# Value Engineering Study Report

**KY 210 Widening Improvements – 4-80154.00**  
From Hodgenville to Campbellsville

*Larue, Green & Taylor Counties, Kentucky*

**Report Date: December 13, 2024**

## VE ALTERNATIVE TS-1

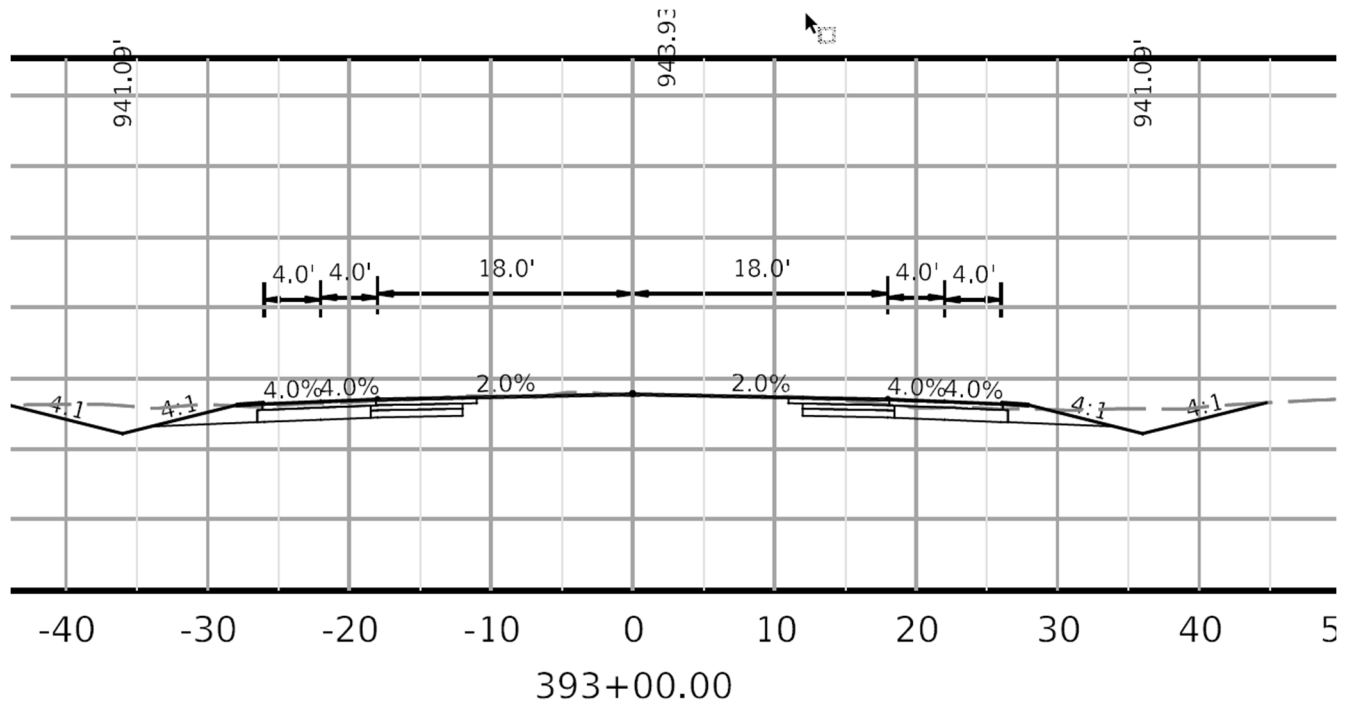
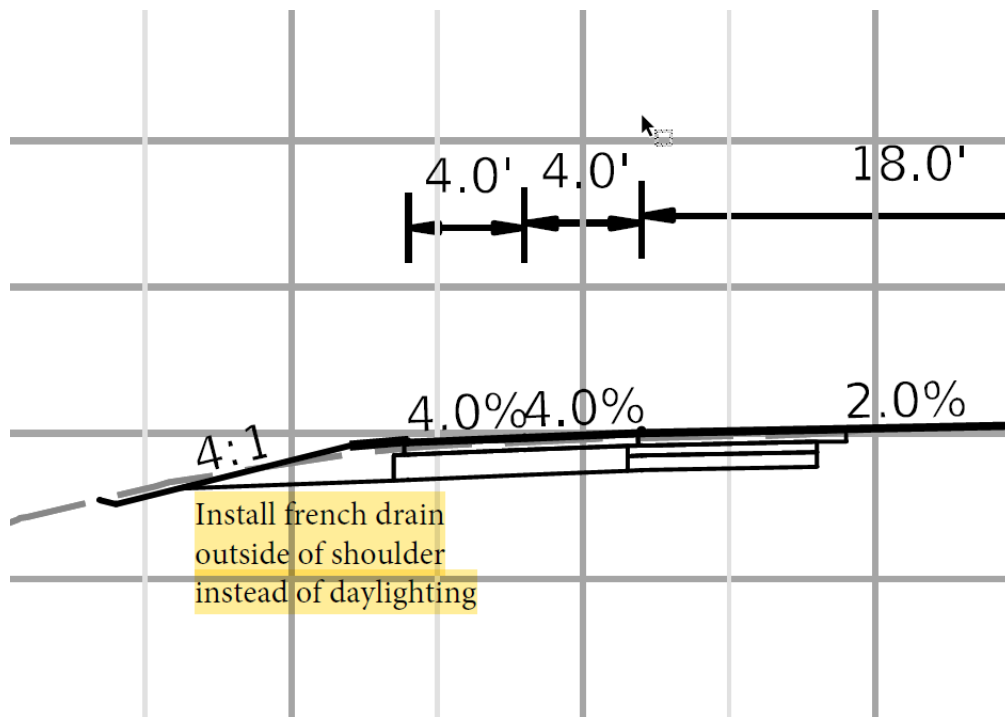
Instead of daylighting the excavation past the shoulder, construct lateral French drains throughout the project at specified spacing to provide drainage for the subgrade.

The VE team recommends eliminating the process of daylighting the shoulders in order to provide drainage for the subgrade. Instead of this process, install lateral French drains at specified spacing along both shoulders to provide the necessary drainage for the subgrade.

After calculations for full length daylighting of sections 1 & 3, we will assume that 40% of the shoulders are daylighted and will be affected by this change. Quantities will be adjusted.

<b>Typical Section Modifications</b>			
TS-1	Provide drainage for existing subgrade with French drain in lieu of daylighting shoulders	Accept	The PDT would like to accept this alternative and evaluate during final design. Several team members stated that they have utilized this approach on other projects and that it

### Revise limits of cement stabilized base

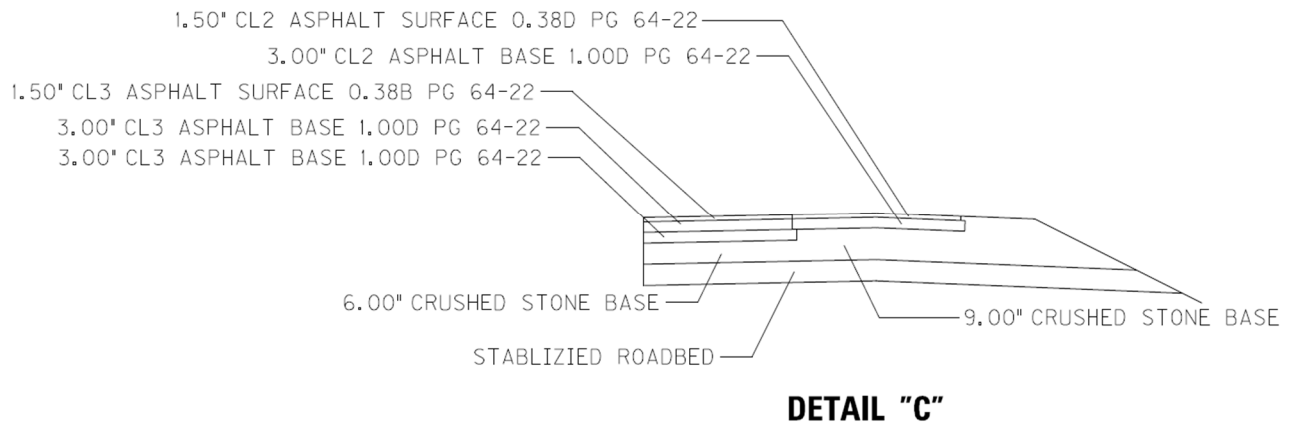
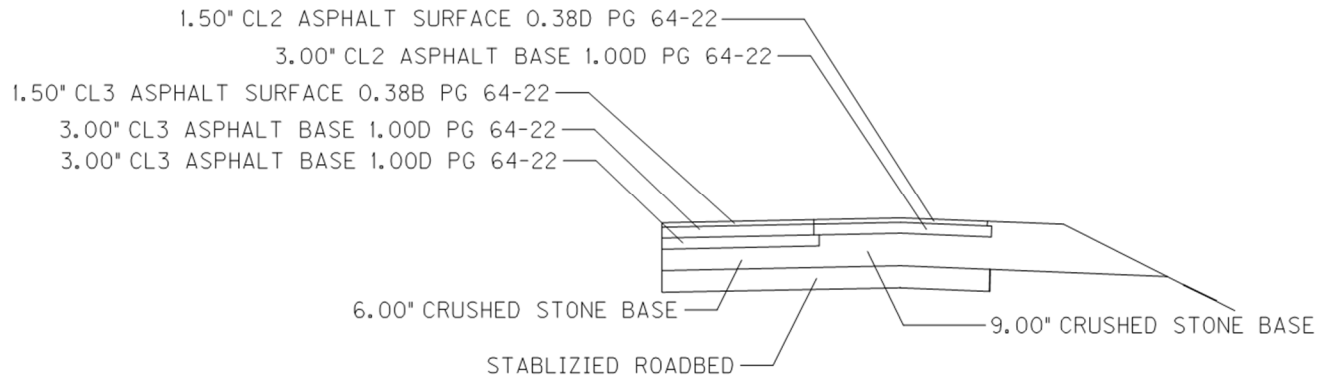
The alternative focuses on the use and cost analysis of the cement stabilization option. The baseline project did include the option of crushed aggregate in lieu of the cement treatment, and this alternative could also be applied to the aggregate application. The use of “bleeders” can be used to provide positive subgrade drainage in the aggregate application.

**Assumptions and Calculations:** For calculations, I could not extract exact square yards of material out past edge of asphalt base, so going to assume an average width of 5.5' on each side of the roadway. I looked at many cross sections and measured the length from edge of paved shoulder to the x-y tie and got an average of 5.5' throughout the project.

Application rates: Cement 54.76 lb/sy, Sand 5 lb/sy, curing seal 2 lb/sy (pulled from section 2 estimate)

Alt No.	Alternative Title	Implement Status	Decision Rationale / Comments
			has worked well, with some time savings during construction.
TS-2	Revise limits of cement stabilized base	Accept	The PDT would like to accept this alternative and modify the plans to bring the stabilized base to the edge of the shoulder instead of daylighting to the slope.
TS-3	Maintain 2' stone base shoulder width at guard rail locations	Accept	The PDT would like to accept this alternative and modify the typical section to show utilizing 2 ft of shoulder width behind the guardrail. The design already includes utilizing the 7 ft guardrail posts.
TS-4	Use 4' of paved shoulders and 4' of rock shoulders in lieu of 8' paved in passing lane sections	Reject	The PDT would like to reject this alternative. There are other locations within the District where the paved shoulder width was reduced to 4 ft and there have been safety issues in those locations. They have also received much criticism from the locals with the reduced shoulder widths.

## VE ALTERNATIVE TS-3

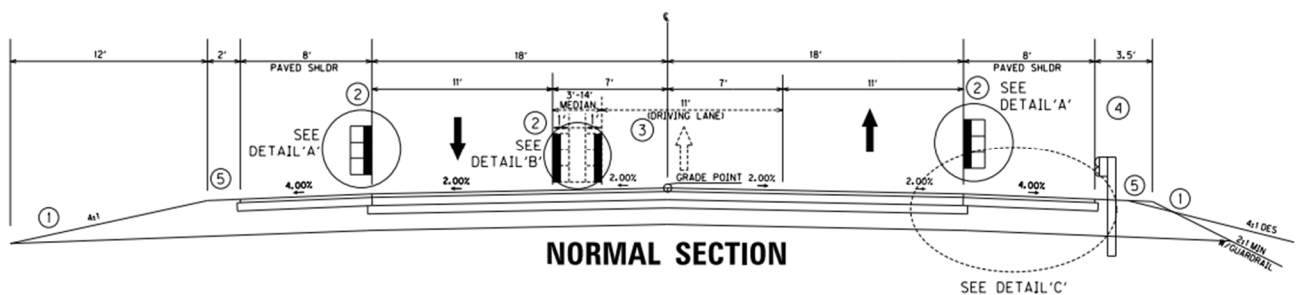
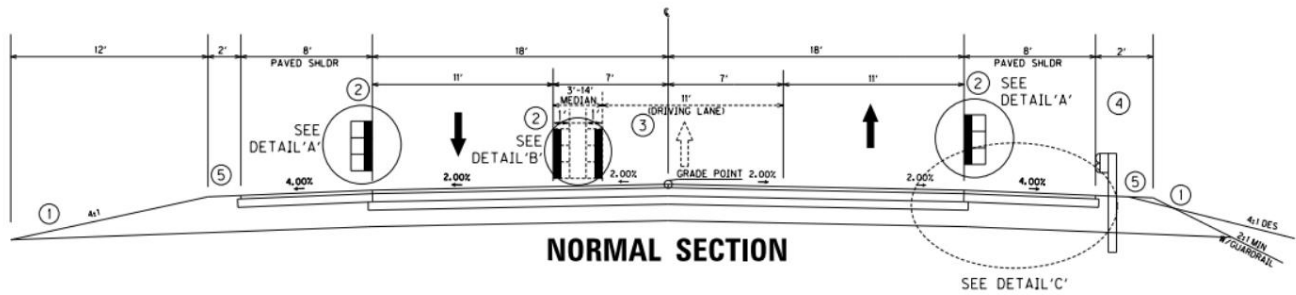
The 2' crushed stone base shoulder as proposed in standard areas of the project would remain consistent throughout the project, potentially reducing labor costs and time associated with the modification of construction equipment to create the larger shoulder areas.

Possible schedule savings due to decreased time in equipment adjustment and/or modification to accommodate a brief shoulder width adjustment to 3.5'.

### Maintain 2' stone base shoulder width at guard rail locations

## VE ALTERNATIVE TS-5

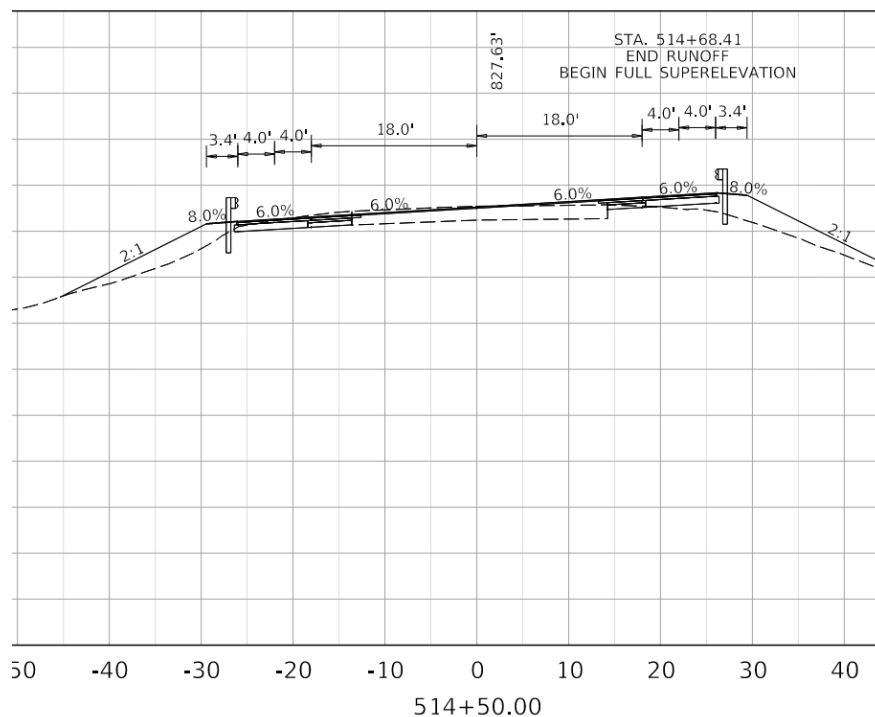
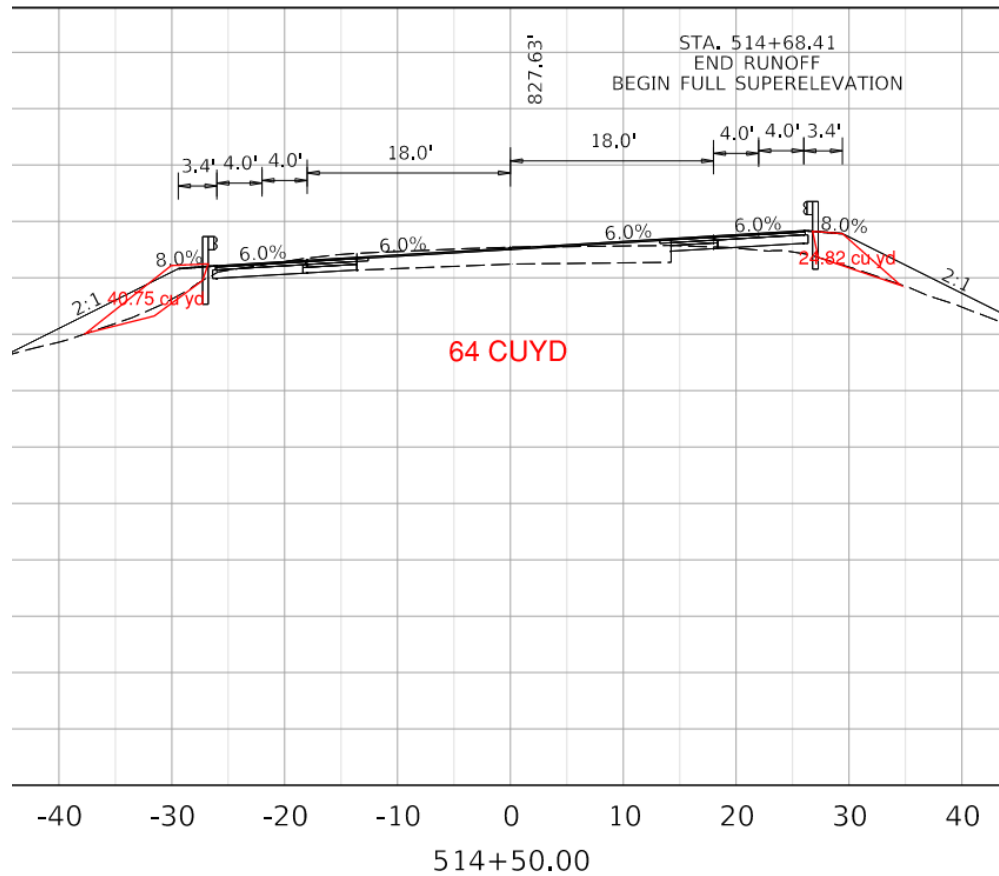
Risks associated with increasing runoff in these areas will need to be resolved and confirmed that local streams and pipe sections will not be impacted.

### Use granular embankment and geotextile for sliver fills
